Bulletin 52-27
DC-10 SC 612

This page transmits Revision 1 for DC-10 Service Bulletin 52-27 to incorporate the following changes:

SERVICE BULLETIN

DOORS - Cargo - Revise Door Latch Actuator Wiring.

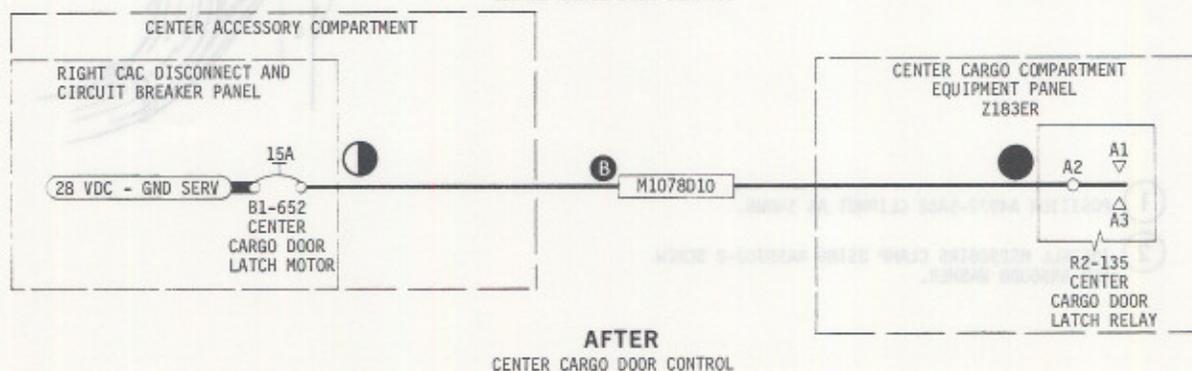
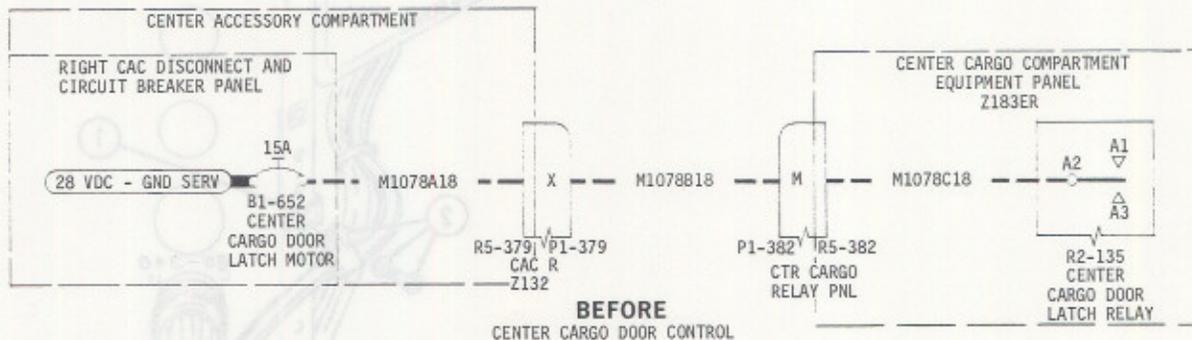
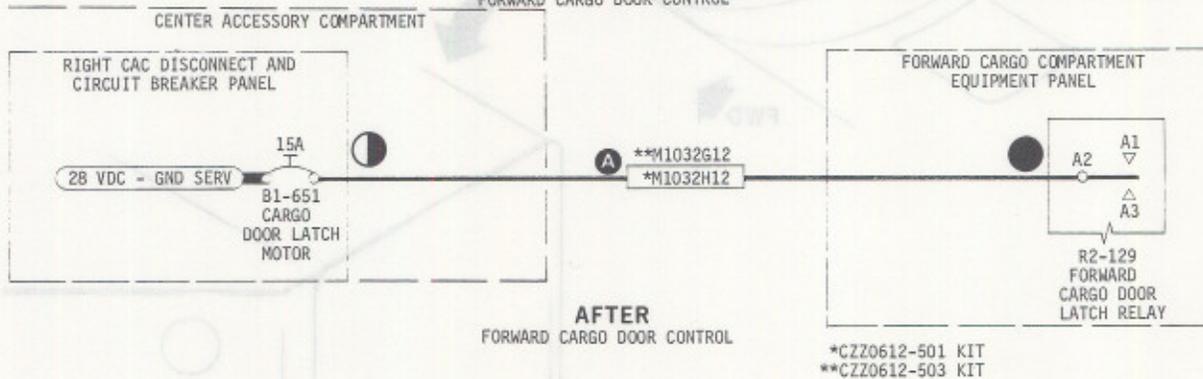
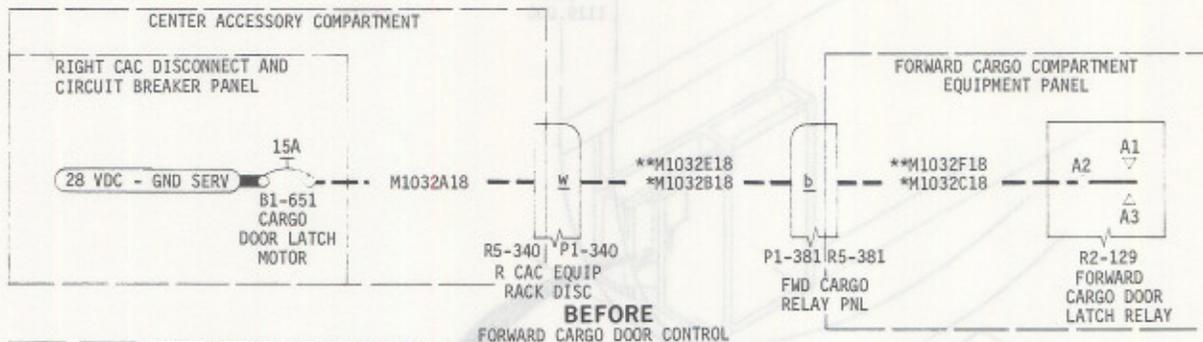
- B. Install clamp in center accessory compartment as shown on Figure 1.
- C. Revise forward, center, and aft cargo door latch actuator wiring as shown on Figure 2, using CZ30812-3 or -5 wire package as applicable. Perform continuity checks during installation.

NOTE: New wiring is to be routed identical to wiring being replaced, except as noted, using existing clamps and new clamp installed in paragraph 2.B.

FIGURE 2 (SHEET 2 OF 2)

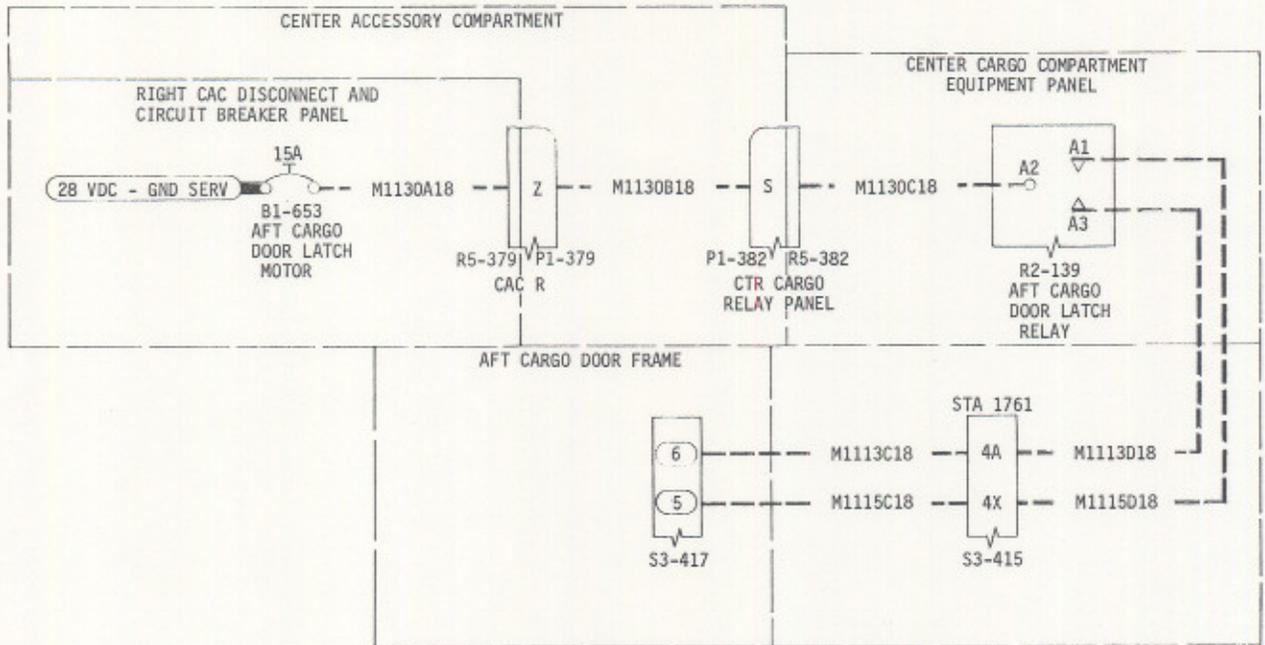
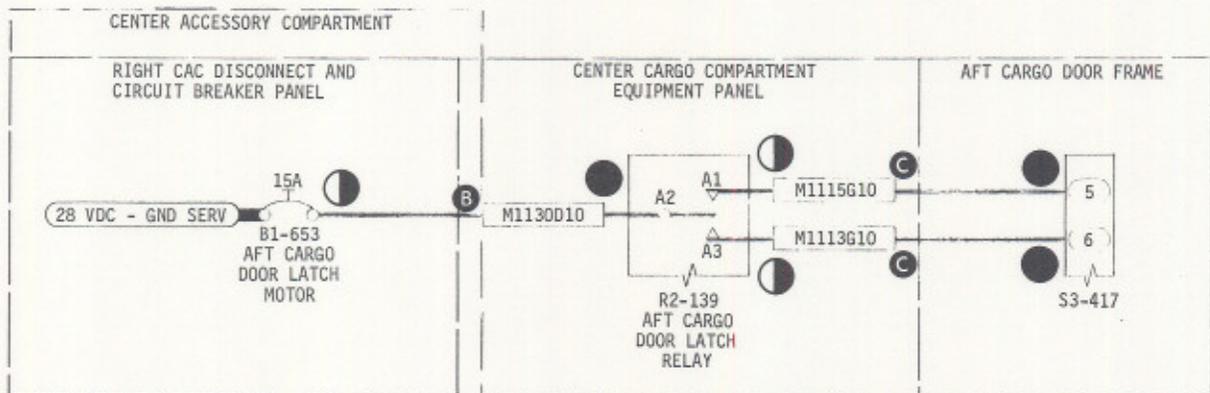
BEFORE
AFT CARGO DOOR CONTROL

AFTER
AFT CARGO DOOR CONTROL

REVISION IS TYPICAL FOR CZZ0612-501 AND -503 KITS, EXCEPT AS NOTED
